Evaluation Kit for RA8D2 Microcontroller Group
EK-RA8D2 v1
Errata

Renesas RA Family
RA8 Series

EK-RA8D2 v1 – Errata

Figure 2. Crystal Oscillator with Incorrect Load Capacitance

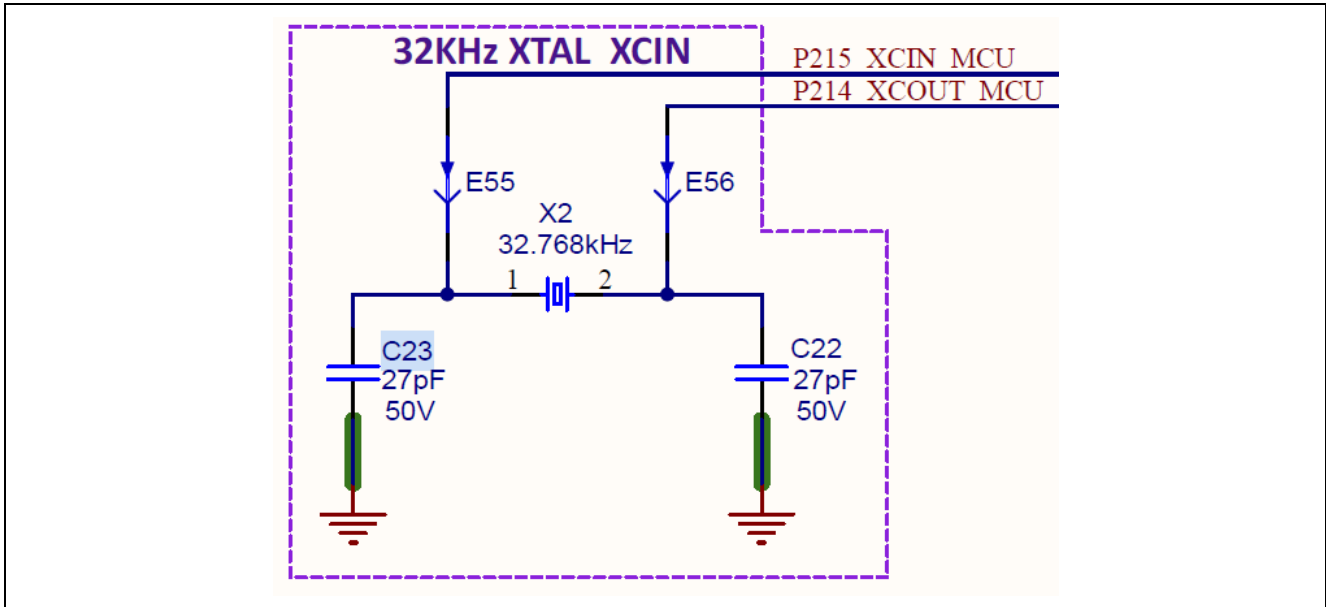
Due to incorrectly specified crystal load capacitance and capacitors C22 and C23 the RTC can be inaccurate in the order of 10 seconds every 24 hours. This is because the fitted crystal ABS07-32.768KHZ-9-T requires a 9pF load capacitance C_L , given by the formula $C22=C23=2*(C_L-C_{stray})$, and so the load capacitors C22 and C23 should be significantly lower values than the fitted 27pF capacitors.

To address this the user can replace the load capacitors, C22/C23, with 8.2pF parts, for example CC0402CRNPO9BN8R2. This value has been tested and found to be appropriate for the device and board configuration.

Figure 3. Touch Position Mapping Error

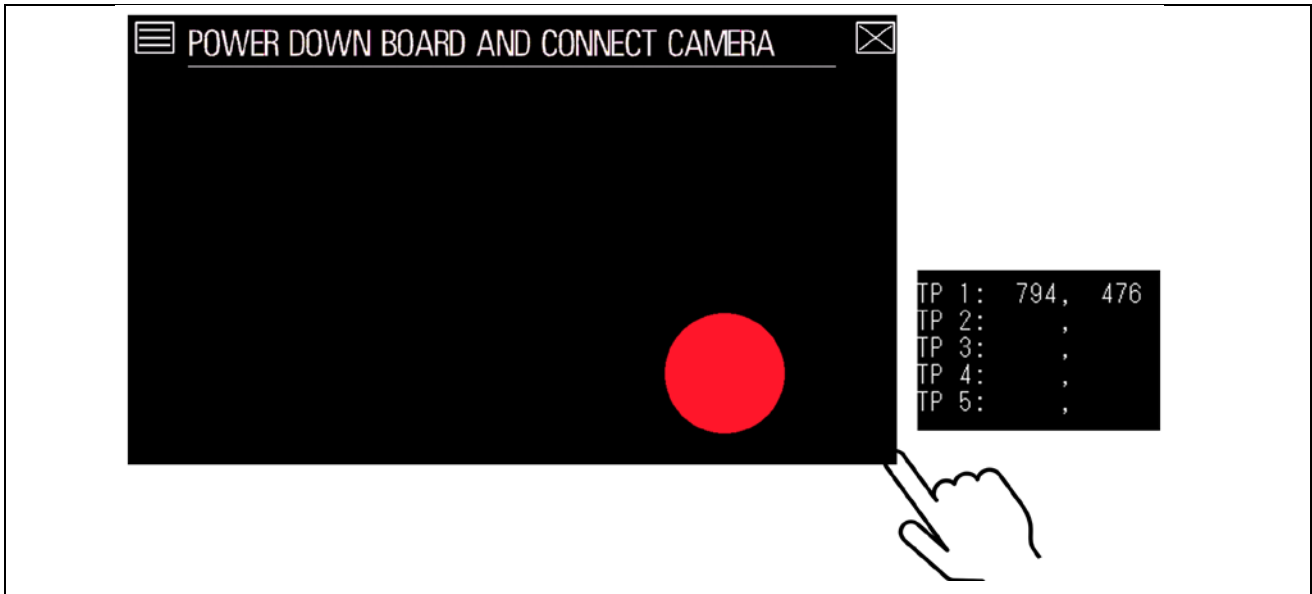
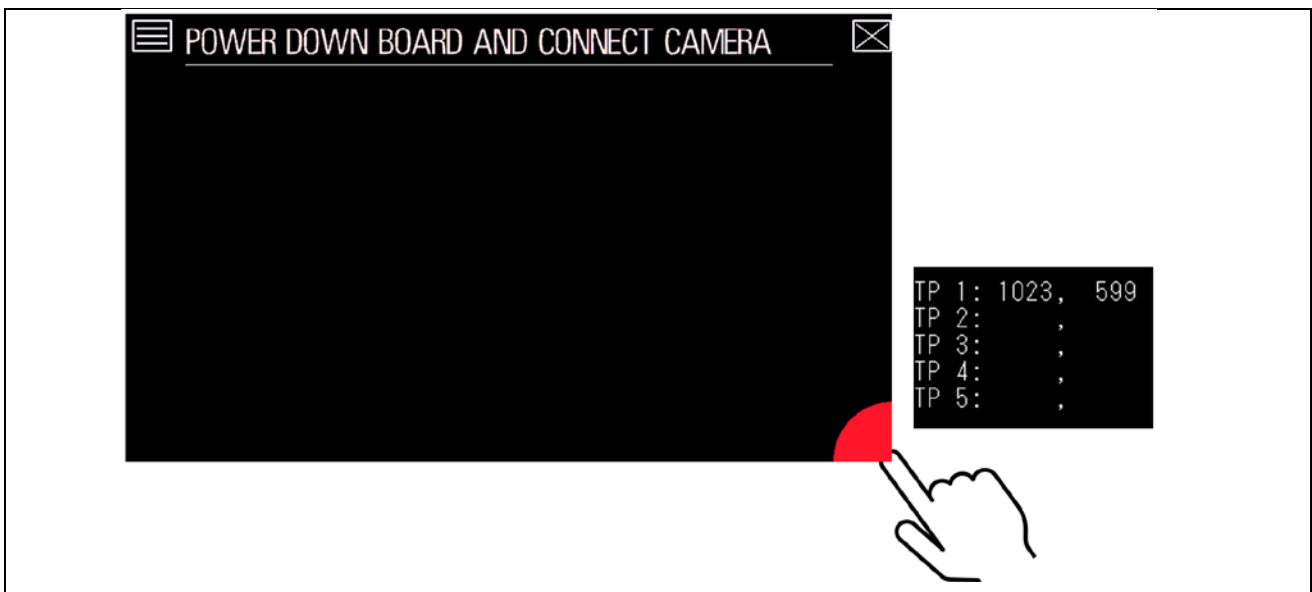
The Parallel Graphics Expansion Board screen has a resolution of 1024 x 600. The Touch Panel on a small number of kits may be incorrectly calibrated to 800 x 480 resolution. The user may find that touch position does not map to the correct position on the screen.

1. Download the associated update package from our website. (r20zz0247eg0200-errata-ek-ra8d2-touchpanel_fix.zip) and extract the contents.
2. Download the latest version of Renesas Flash Programmer (RFP) from our website. (v3.21 or any later version).

3. Start RFP and open the project configuration file from the downloaded and extracted package. (ek-ra8d2_app_lcd_ek_par_1_touchpanel_fix.rpj)
4. Connect the EK-RA8D2 and the APP_LCD_EK_PAR_1 screen.
5. Connect the USB cable between the EK-RA8D2 Debug USB connector (J10) and your computer.
6. Press Start on the RFP dialog.
